STAFF RECOMMENDATION 2805 27th Avenue South November 15, 2017

Application: New construction – addition
District: Hillsboro-West End Neighborhood Conservation Zoning Overlay
Council District: 18
Map and Parcel Number: 11703001000
Applicant: Manuel Zeitlin
Project Lead: Melissa Baldock, melissa.baldock@nashville.gov

| <p>Description of Project: Application is to construct a rear addition with an attached garage at the basement level.</p> <p>Recommendation Summary: Staff recommends approval of the project with the following conditions:</p> <ol style="list-style-type: none">1. Staff approve the final details, dimensions and materials of windows and doors prior to purchase and installation;2. Staff approve a brick sample;3. Staff approve a stone sample;4. Staff approve the roof shingle color, material, and texture; and5. The HVAC be located behind the house or on either side, beyond the mid-point of the house. <p>With these conditions, staff finds that the project meets Section II.B. of the Hillsboro-West End Neighborhood Conservation Zoning Overlay.</p> | <p>Attachments A: Site Plan B: Elevations</p> |

SITE PLAN

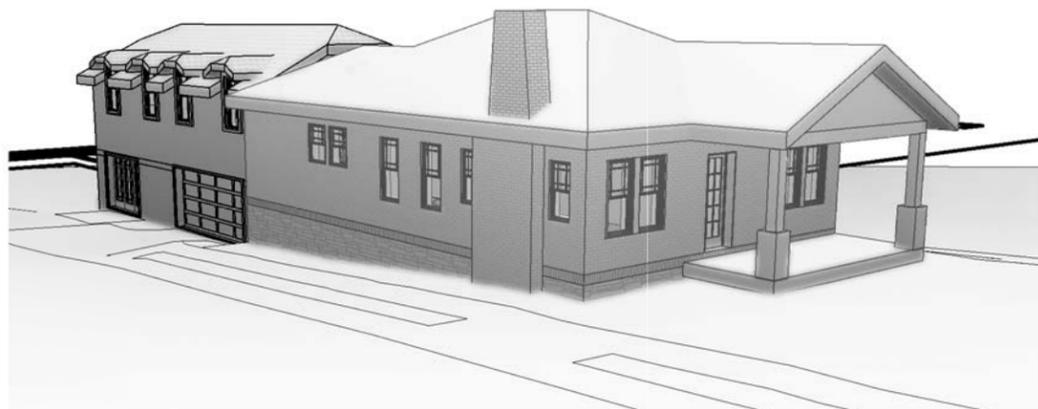
Setback & Rhythm of Spacing: The addition meets all base zoning setbacks. It will be five feet (5') from the right side property line, more than twenty feet (20') from the left side property line, and more than eighty-five feet (85') from the rear property line. Staff finds that the addition's setbacks are appropriate and will not affect the rhythm of spacing of historic houses along 27th Avenue South. Staff therefore finds that the project meets Sections II.B.1.c. and II.B.2. of the design guidelines.

Orientation: The addition will not alter the historic house's orientation towards 27th Avenue South. Vehicular access to the site will be via a eleven foot (11') wide driveway on the left side of the property. The site lacks alley access, so a new driveway is appropriate. The driveway will have concrete strips, which is appropriate, and will be approximately eleven feet (11') wide. . Staff finds that the addition meets Sections II.B.1.f. and II.B.2 of the design guidelines.

| ELEVATION | A2 |

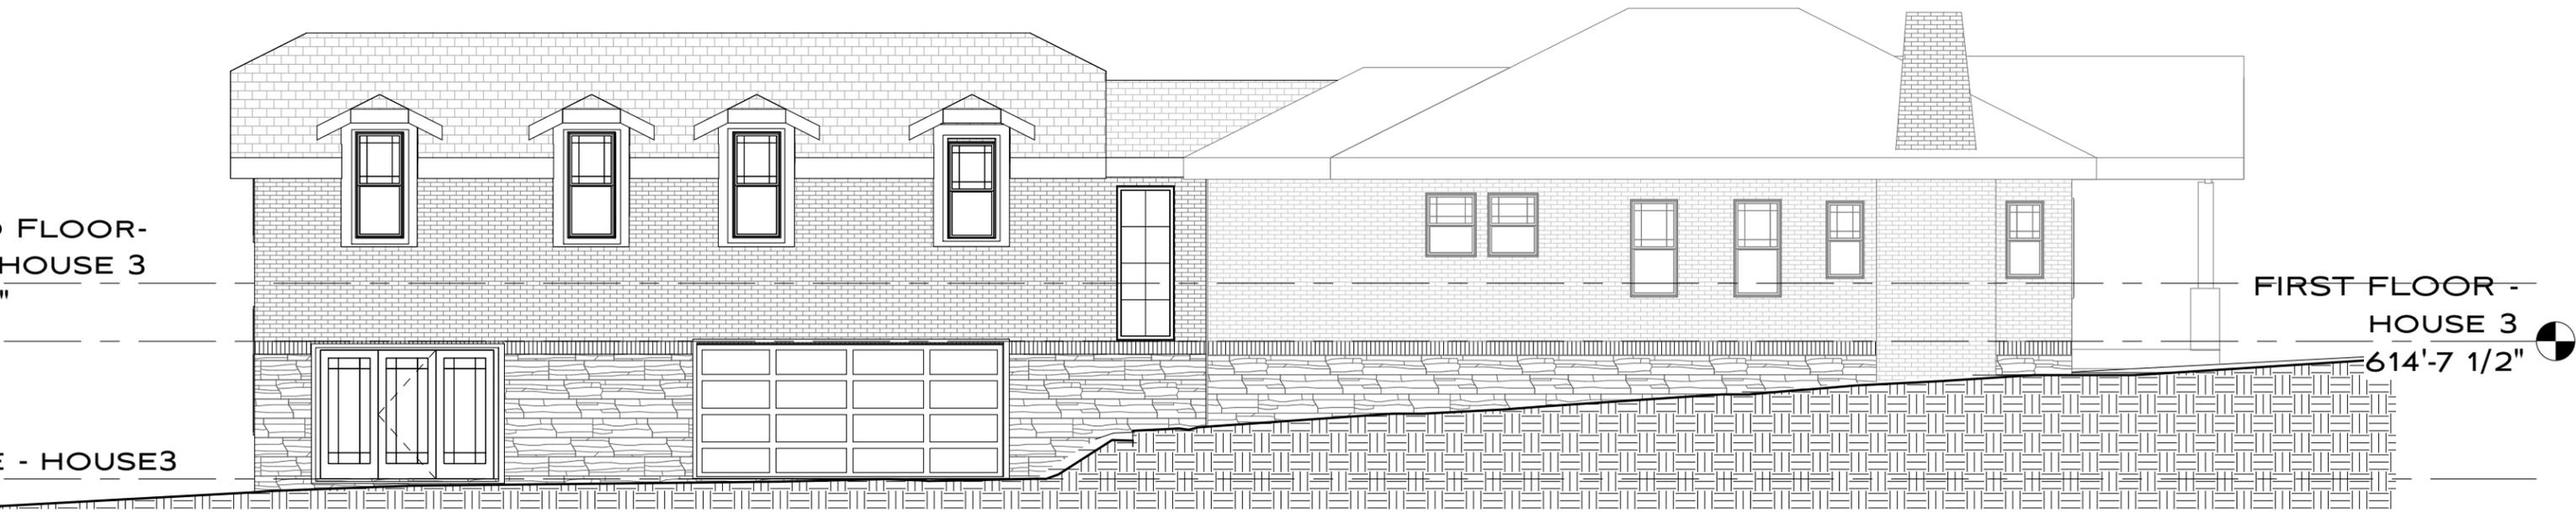
Height & Scale: The historic house is one story in height, and the addition will be one story above a basement level. The addition's foundation and eave heights will match those of the historic house. Its ridge height will be lower than the ridge height of the historic house. At its tallest, the addition will be one foot (1') shorter than the historic house. Staff finds that the addition's height is appropriately subordinate to the historic house. The addition is inset one foot, six inches (1'6") on the right elevation for a depth of fifteen feet, six inches (15'6"). After this depth, the addition steps back out to match the line of the historic house. On the left elevation, the entire addition is inset five feet, six inches (5'6") from the back corner of the house. Staff finds these insets to be appropriate for one-story addition above a raised basement.

Roof form: The historic house has a hipped roof form with a slope of 6/12. The proposed addition has a clipped gable roof form, also with a 6/12 pitch. The back portion of the addition includes wall dormers. MHZC typically does not approve wall dormers because the design guidelines state that dormers should be inset two feet (2') from the wall below. Staff, however, finds the proposed wall dormers to be appropriate for a few reasons. They are located towards the back of the house, at a point approximately sixty-feet (60') back from the front of the house and more than one hundred feet (100') back from the street. Therefore, they will not be highly visible. In addition, the infill is largely one story in height, with a raised basement; the wall dormers will not create a house that is out of scale with the historic context. Staff therefore finds that the proposed roof forms meet Section II.B.1.e. and II.B.2. of the design guidelines.

Proportion and Rhythm of Openings: No changes to the window and door openings on the existing house were indicated on the plans. The windows on the proposed addition are all generally twice as tall as they are wide, thereby meeting the historic proportions of openings. There are no large expanses of wall space without a window or door opening. Staff finds the project's proportion and rhythm of openings to meet Sections II.B.1.g. and II.B.2. of the design guidelines.

1. Staff approve the final details, dimensions and materials of windows and doors prior to purchase and installation;
2. Staff approve a brick sample;
3. Staff approve a stone sample;
4. Staff approve the roof shingle color, material, and texture; and
5. The HVAC be located behind the house or on either side, beyond the mid-point of the house.

| ELEVATION | A3 |

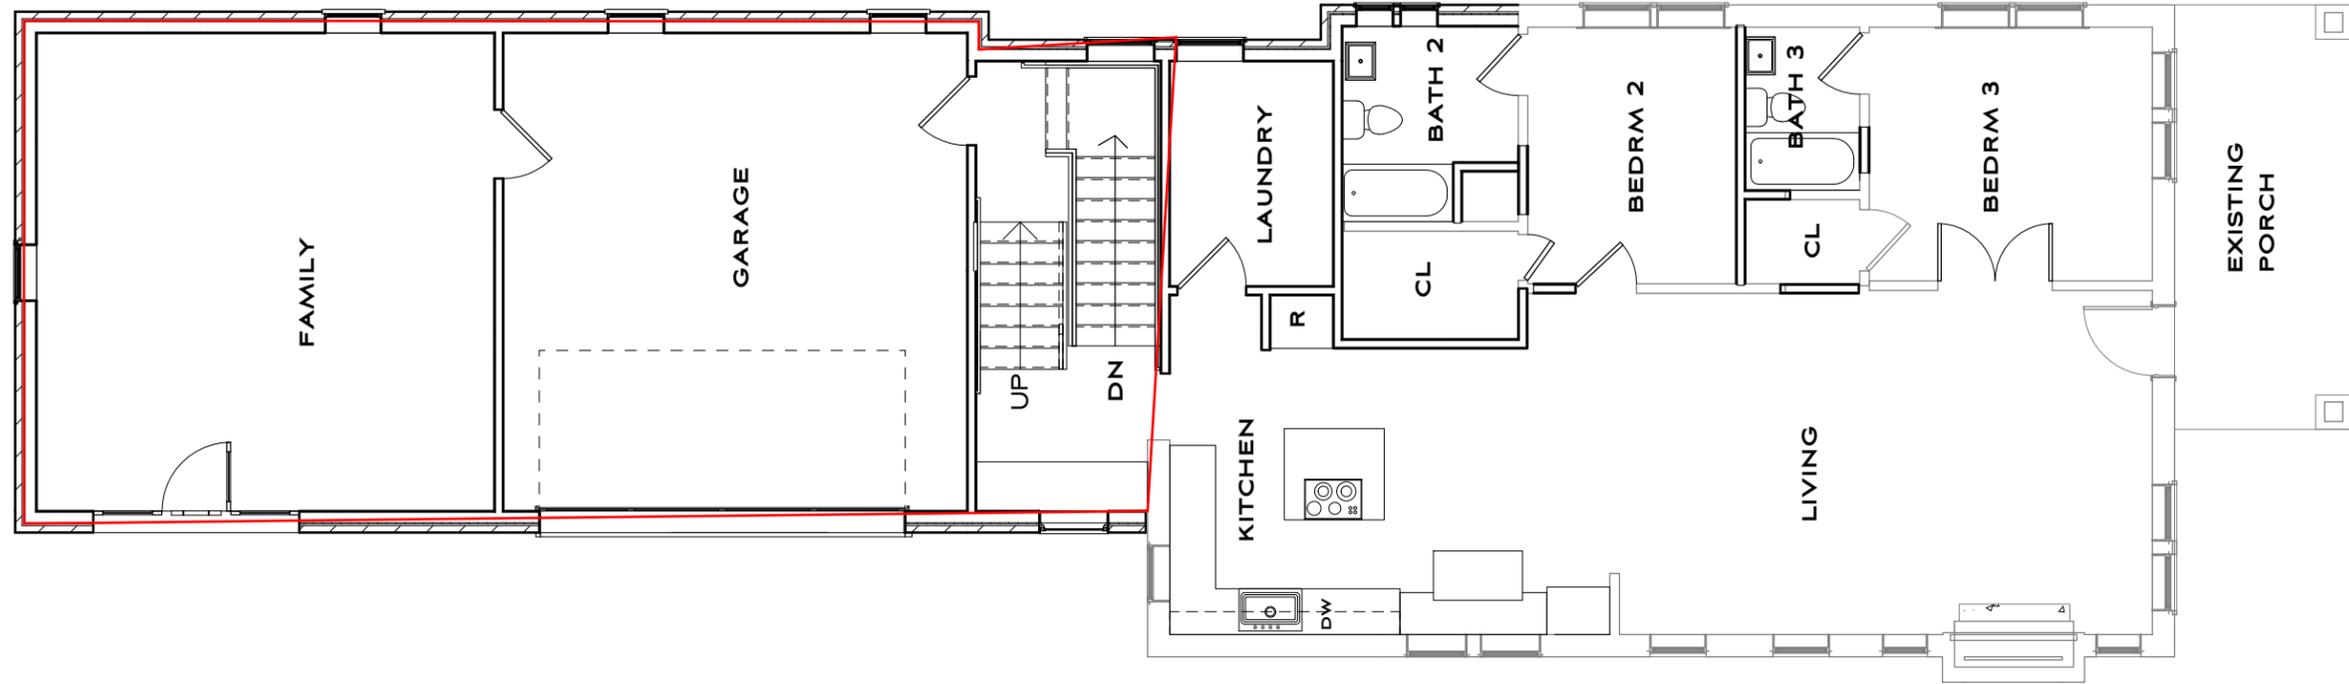
Appurtenances & Utilities: No changes to the site's appurtenances were indicated on the drawings. The location of the HVAC and other utilities was also not noted. Staff recommends that the HVAC be located on the rear façade, or on a side façade beyond the midpoint of the house.

PROPOSED FLOOR
PLANS
11-07-17

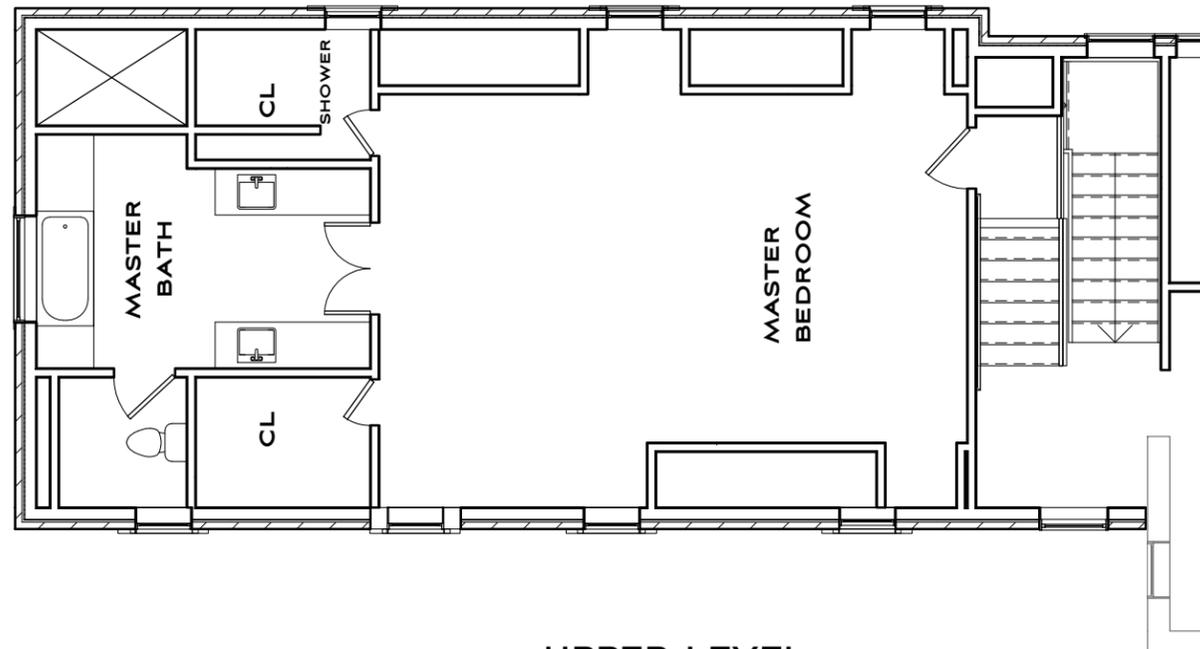
Outbuildings: The infill includes an attached garage. Staff finds that the attached garage meets the design guidelines because it is located fully at the basement level and because it is located towards the rear of property, where garages were historically located. The garage bays will be inset approximately five feet, six inches (5'6") from the wall of the historic house, helping to reduce their visibility from the street. Staff finds that the proposed attached garage meets Section II.B.1.h. of the design guidelines.
